NOTICE OF PROPOSED DEVELOPMENT

5 TERN CIRCLE, PRIMROSE SANDS

DWELLING

APPLICATION NO: 5.2025.208.1

PROPOSED SITE PLAN LG 3

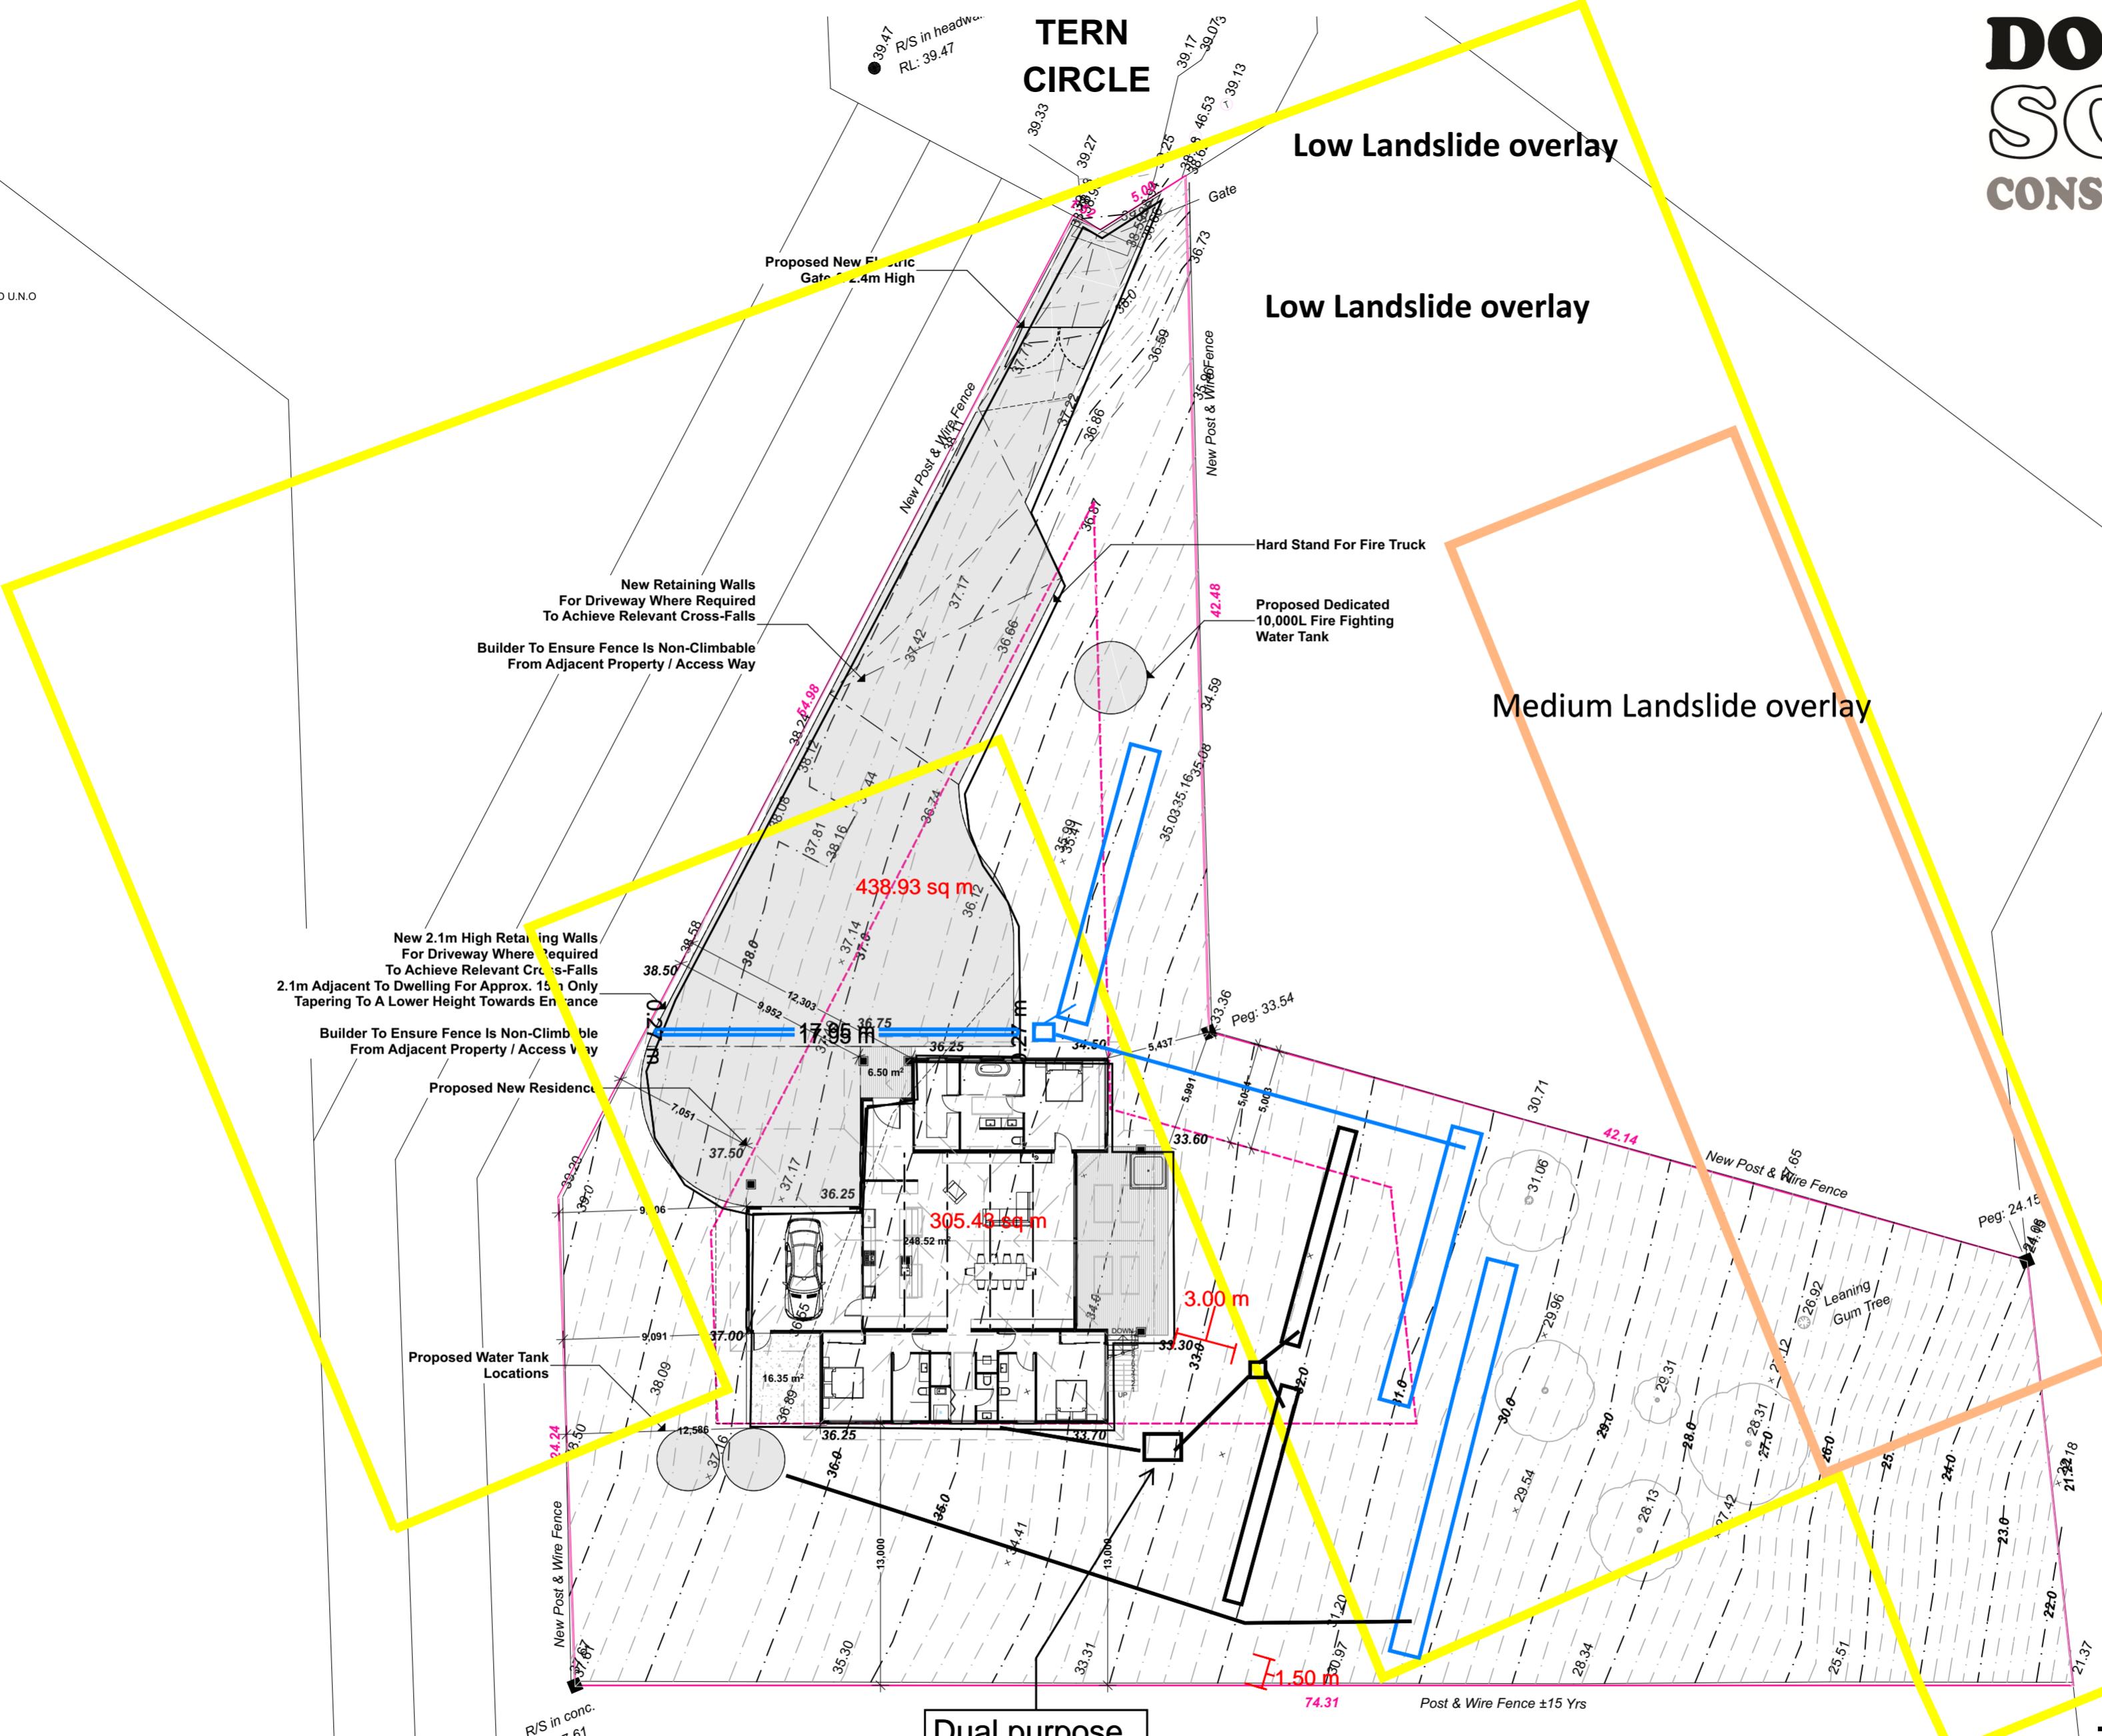
8. Demonstrate Compliance with SOR – S2.7.1 A1 or P1 – Southern Beaches On-Site Wastewater Management Code of the Tasmanian Planning Scheme - Sorell by providing a plan indicating the location of the proposed wastewater land application area. **Now attached from Robyn Doyle.**

The site Plan indicates how the LAA may be located outside of the Low Landslide hazard area. Risk assessment completed to address P2 of the *Directors Guidelines 2016* - Risk Considered low. The deep windblown sand deposits will provide a high level of soil treatment. There will be at least 2.4 m of unsaturated sand soil below the base of each absorption trench and distribution along the length of all trenching will be provided via distribution box after the septic tank and levelled slotted pipe installed in the upper of the trench aggregate.

NORTH ELEVATION

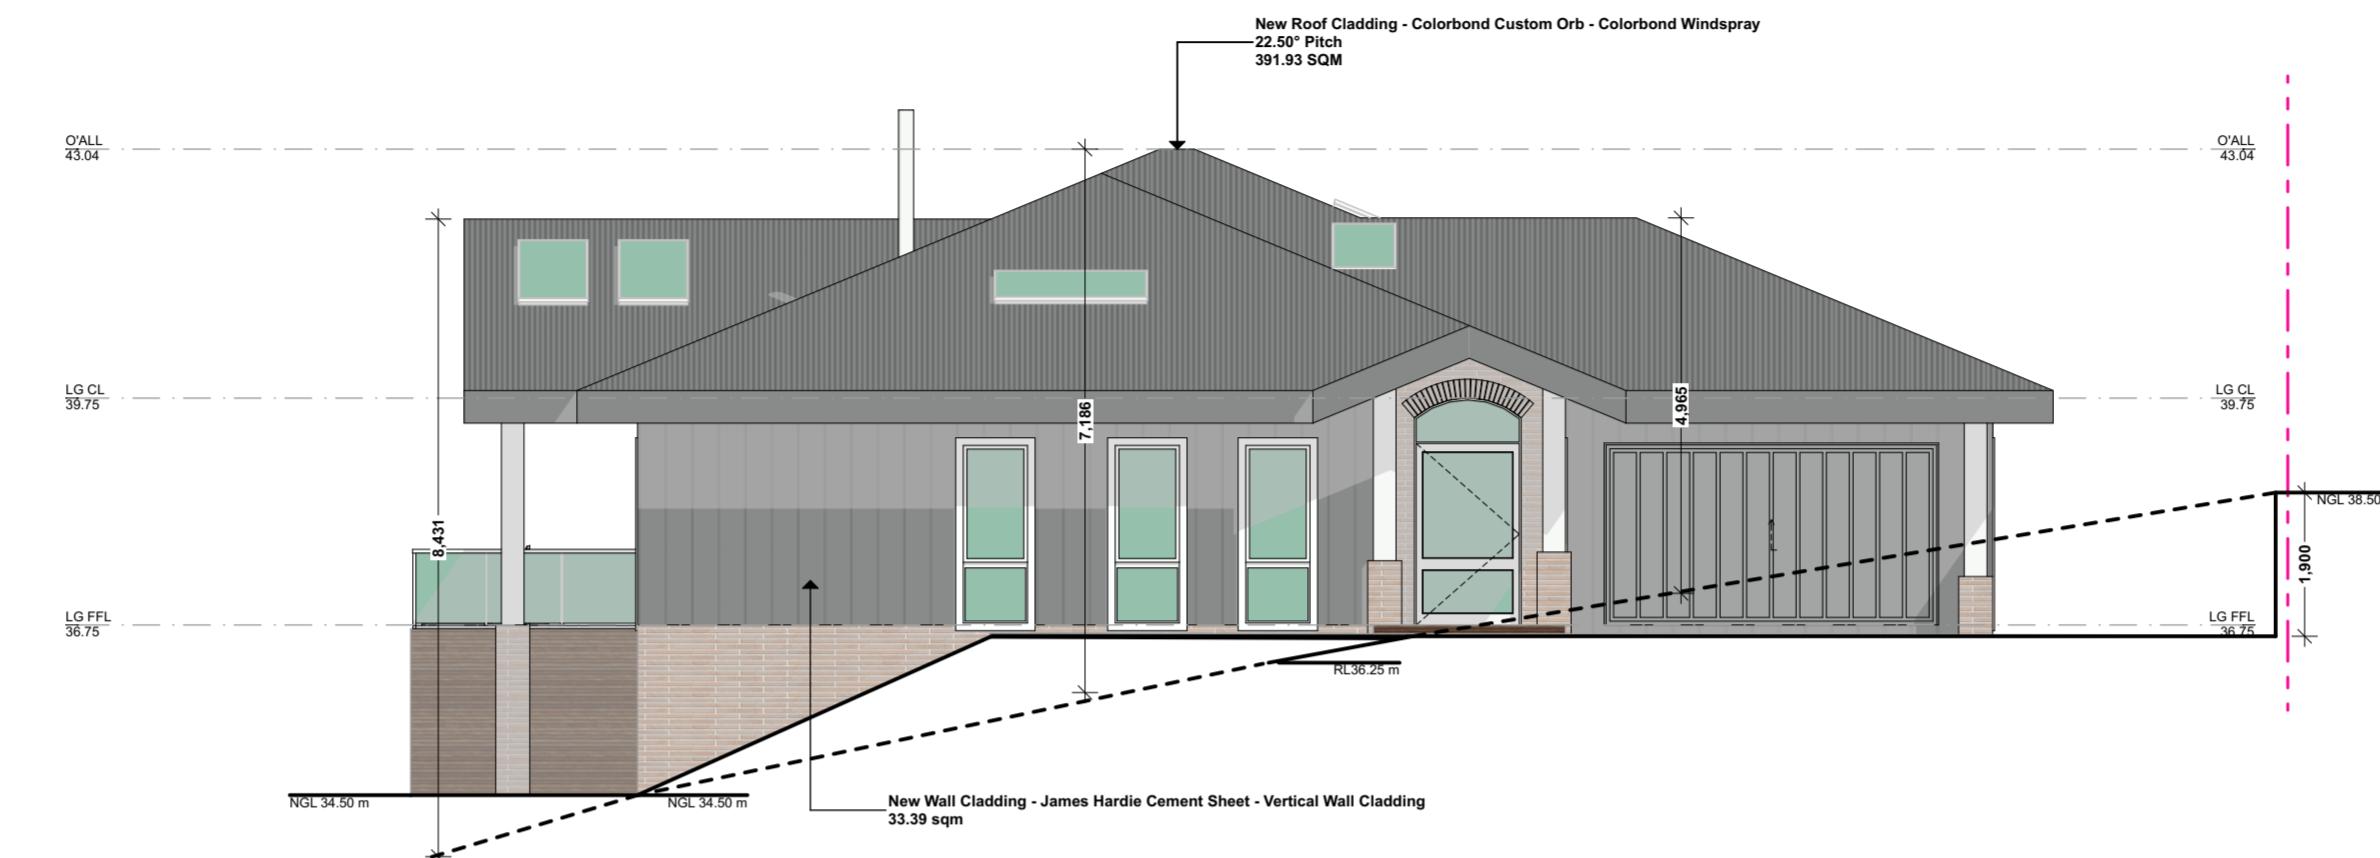
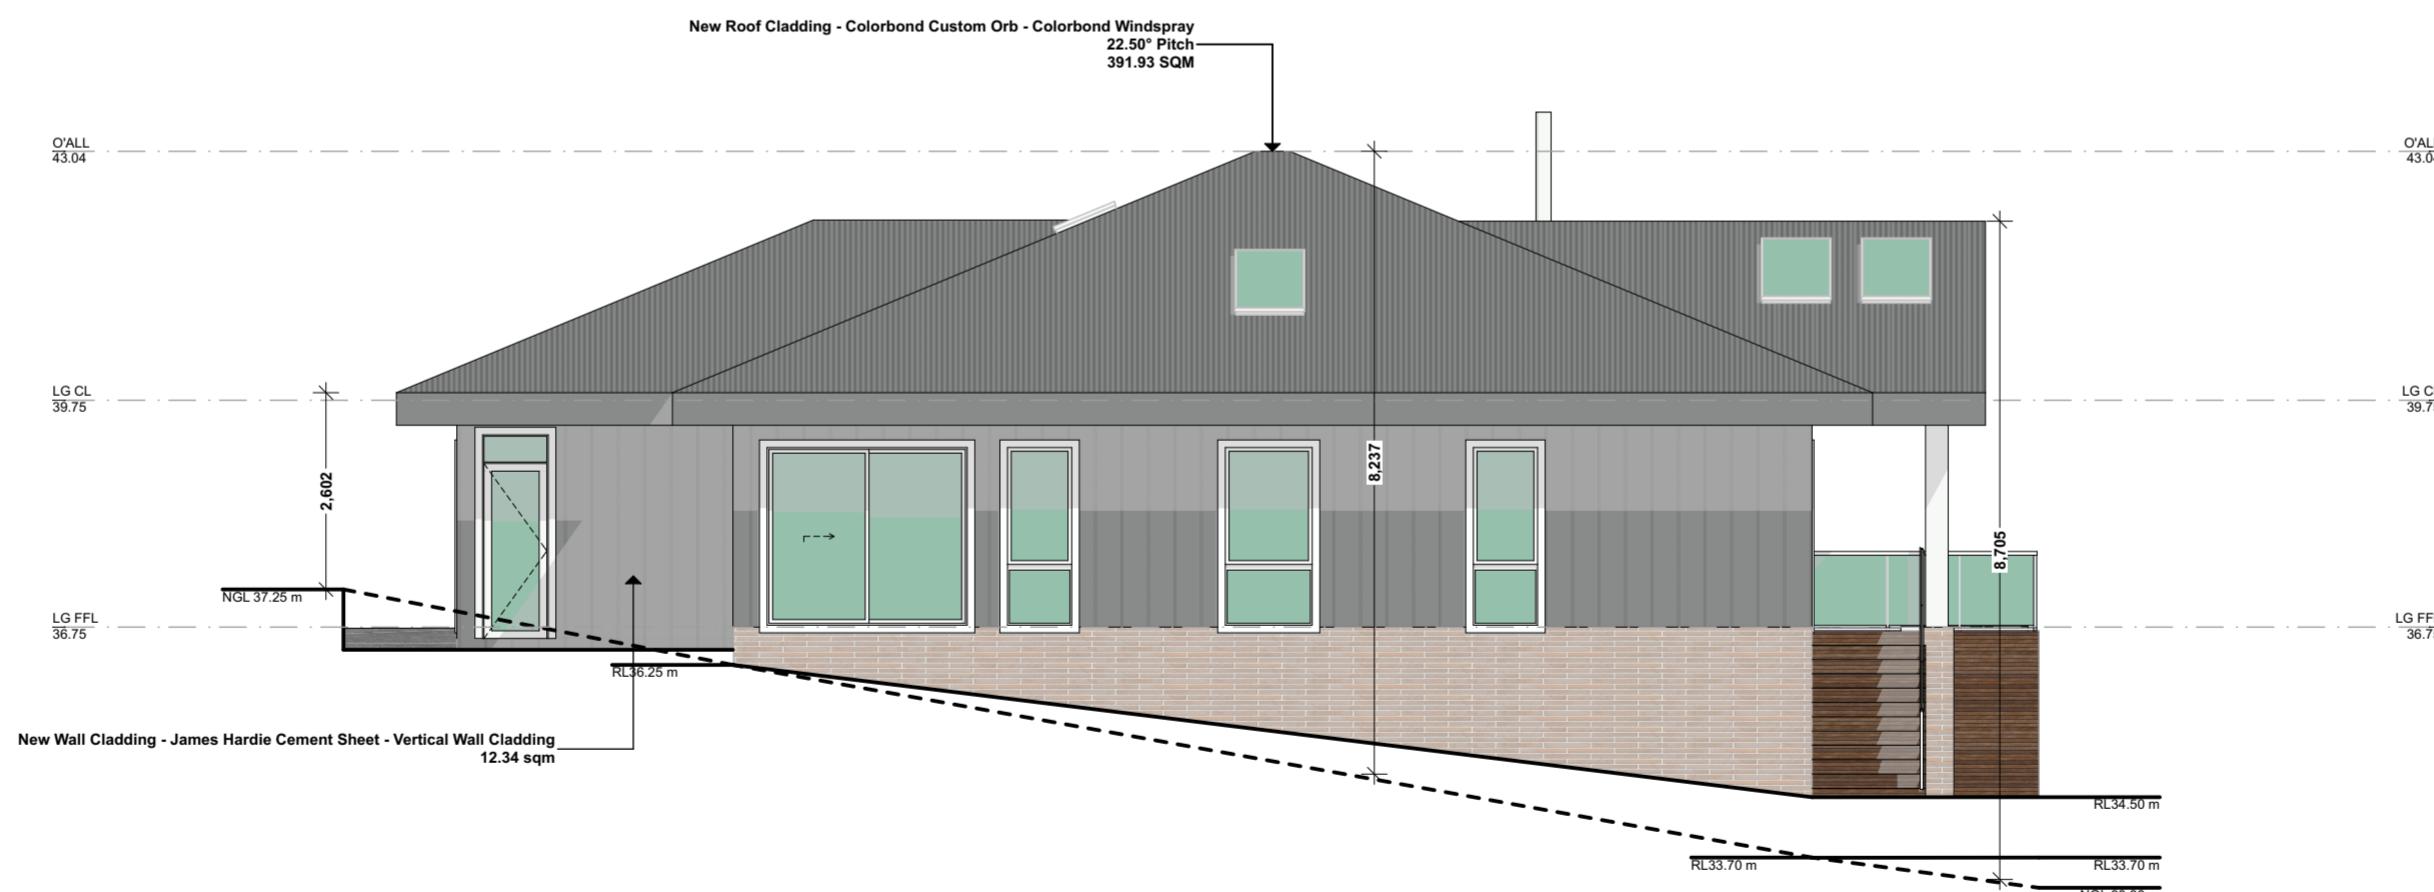
2. Amended elevations that include reference to natural ground level, and show the maximum proposed height of the dwelling above natural ground level. **The proposed max heights have been nominated on the northern and southern elevations, with additional dimensions and the RL levels changed to note NGL, where applicable.**

SCHEME	PROVISION	ACCEPTABLE SOLUTION	PERFORMANCE CRITERIA	COMPLIANCE	DEVELOPMENT RESPONSE
10.4.2	Building Height	A1 A dwelling must have a building height not more than 8.5m.	P1 The height of dwellings must be compatible with the streetscape and not cause an unreasonable loss of amenity to adjoining properties having regard to: (a) the topography of the site; (b) the height of buildings on the site and adjacent properties; (c) the bulk and form of existing and proposed buildings; (d) sunlight to habitable rooms and private open space of dwellings; and (e) any overshadowing of adjoining properties.	COMPLIES	The proposed structure will be under the required height limit of 8.5m, with a maximum height of 7.6-7.8 at the highest point (from NGL).

PROPOSED RETAINING WALL ELEVATION 7

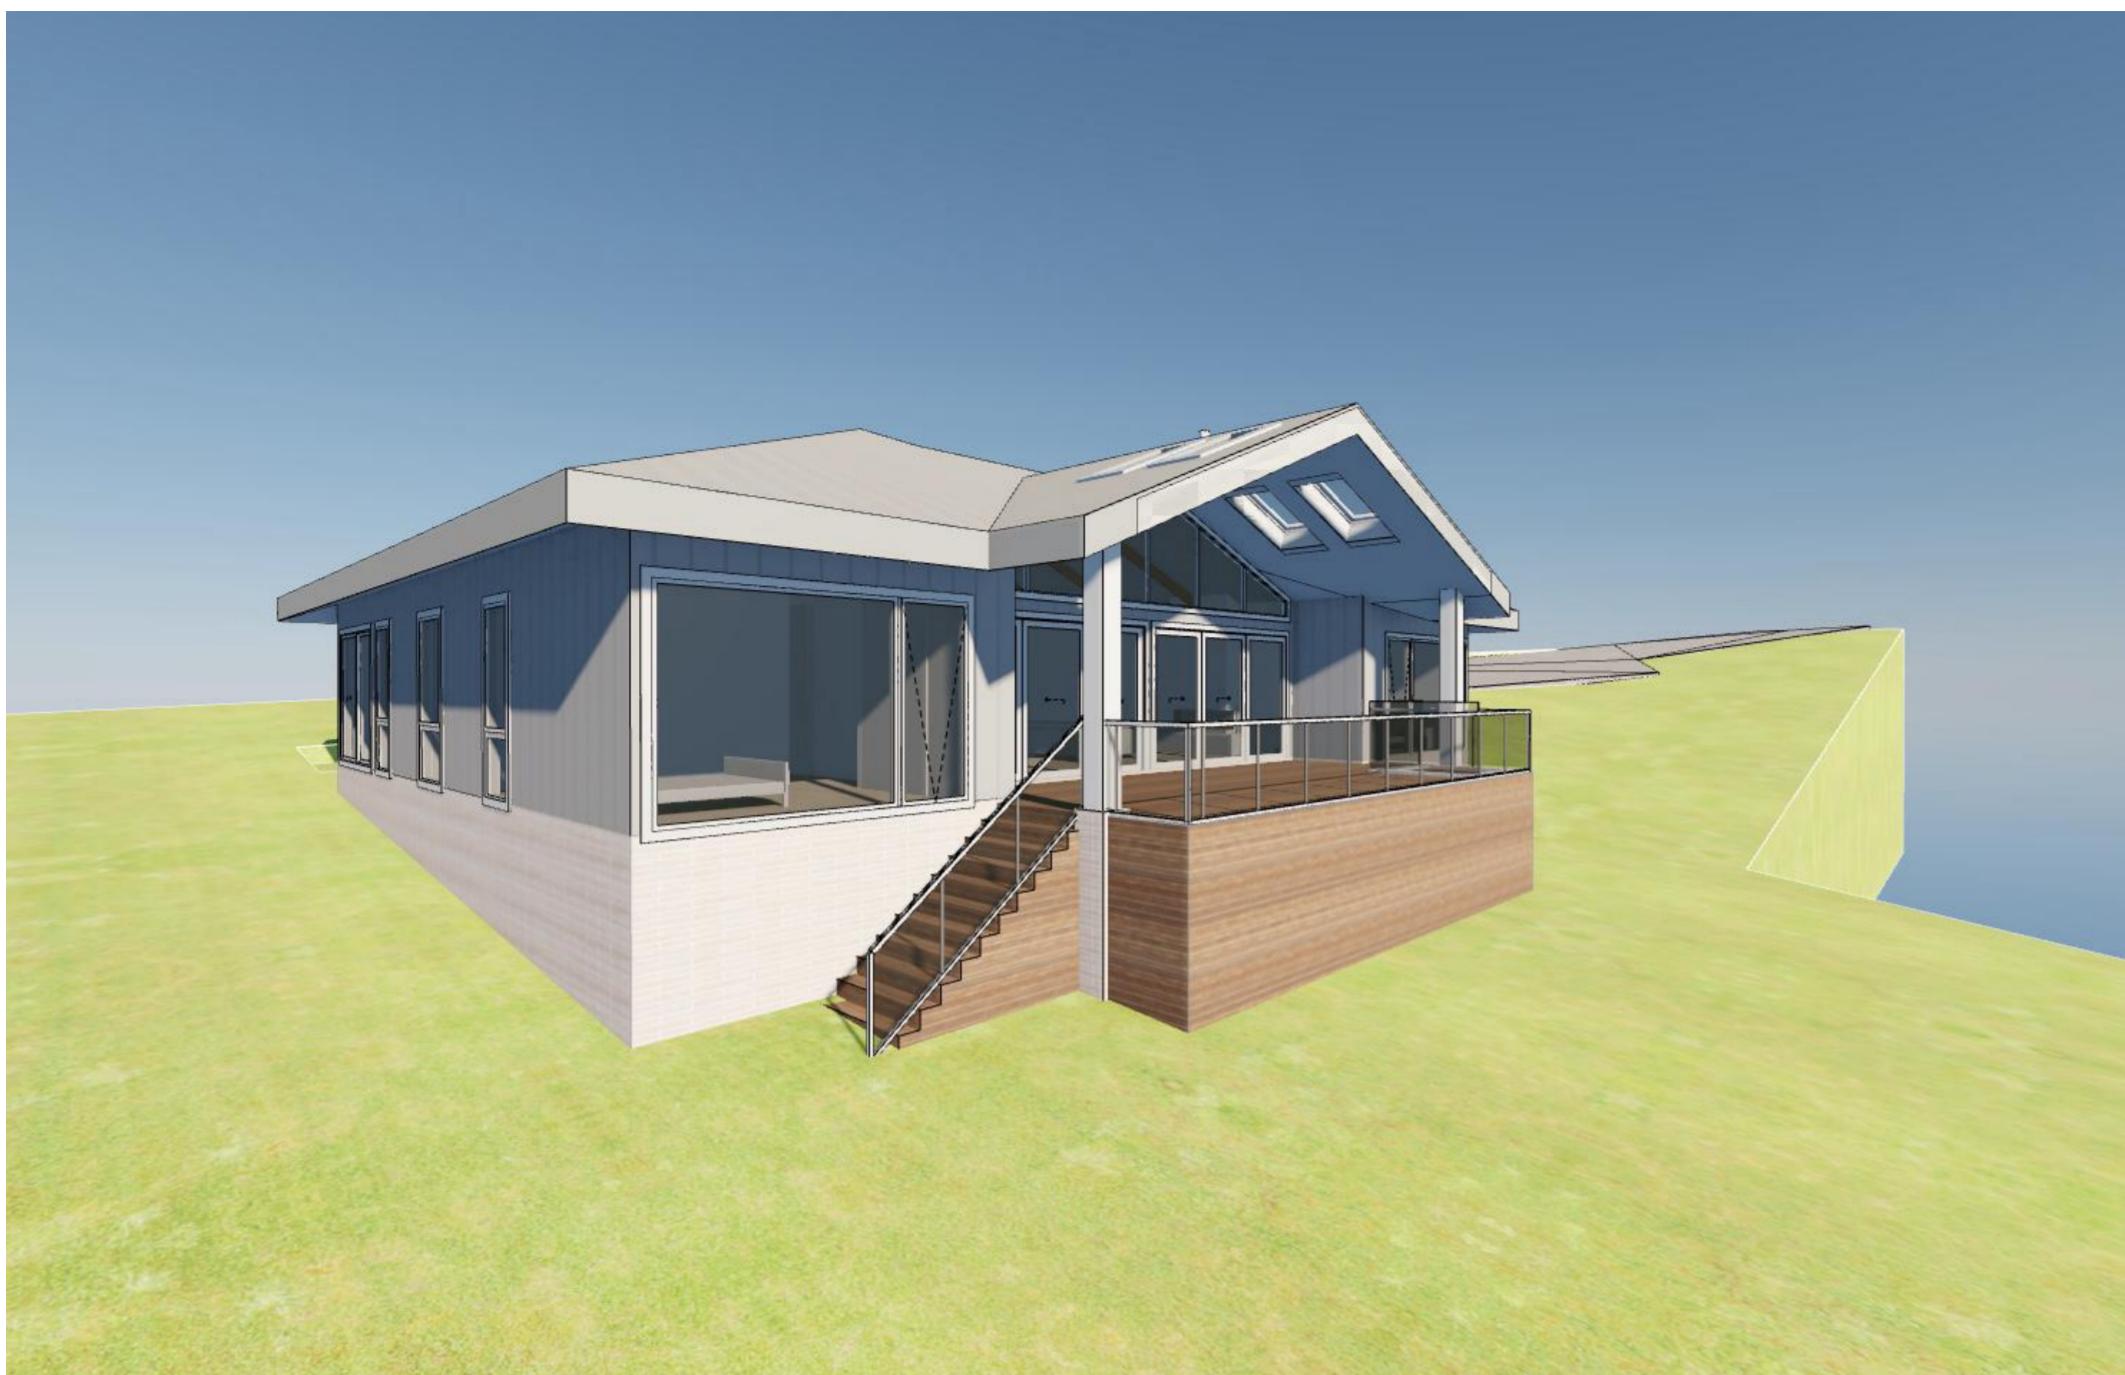
3. Elevations of the proposed retaining wall to show the extent of cut and fill proposed. **An additional elevation of the entire driveway has now been provided with height dimensions for you to review, with the max height of 2195 adjacent to the house.**
